PROTECTION PLAN REVISION FOR SHORELINE PROTECTION SYSTEM AT SITE 8 WITH
TRANSMITTAL LETTER NAS KEY WEST FL
3/10/1997
BECHTEL ENVIRONMENTAL INC

SUBJECT: Bechtel Job No. 22567
Department of the Navy Contract No. N62467-93-D-0936
DO 0004, NAS KEY WEST, SHORELINE PROTECTION SYSTEM - PPR-321-011
Subject Code: 5320

PROJECT PLAN REVISION

Document Name and No. Remediation Work Plan (Chron 3295) Rev. 0 PPR # 321-011

EXPECTED PERFORMANCE OF ARMORFLEX

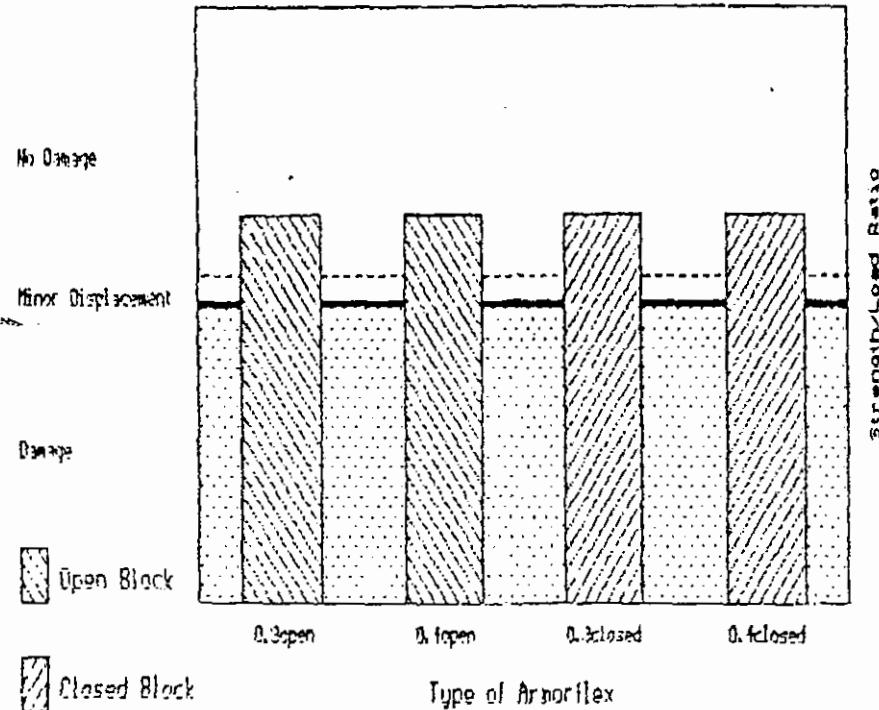
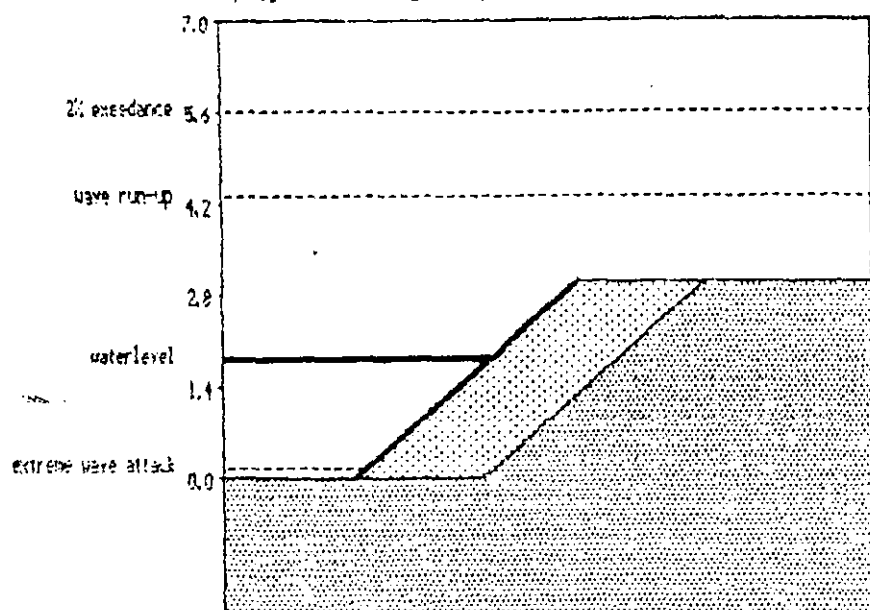
Attached is a revised Nicolon "Wave" program printout for the reduced thickness block of 190mm (7.5 in.). The analysis shows that a normal thickness block of 190mm allows "no damage" to the integrity of the system. Therefore, the revised block thickness is acceptable for this application.

In addition to the reduced block thickness, recent changes to the configuration of this embankment slope reduce the overall impact of waves onto the system. These changes do not negatively impact the design; therefore, the design remains as previously submitted.
